**ADDENDUM TO BID
RECONSTRUCTION OF AIRPORT DRIVE AND FALCON ROAD
BID NO.: 814-PW-113
EDA AWARD NO.: 06-01-05752**

ADDENDUM NO.: 2

Sheet 128 – Drainage and Utility Plans Drainage Details

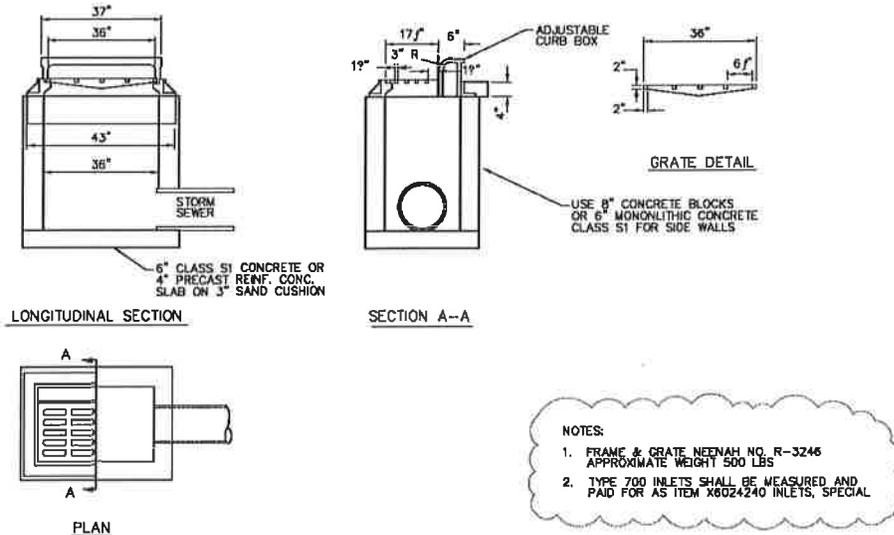
STANDARD INLET TYPE 700

9. Pay item X6024240 for inlets special does not indicate the size required (i.e. 4' x 4'). We are also unable to find this information in the plans. Please specify what size(s) special inlets will be required. Is the intention that the inlets special should be constructed according to the detail for standard inlet type 700 as shown on plan sheet 128?

Response: *The inlets, special are to be constructed as noted in the Type 700 detail on sheet 128. The item detail will be clarified in Addendum No. 2*
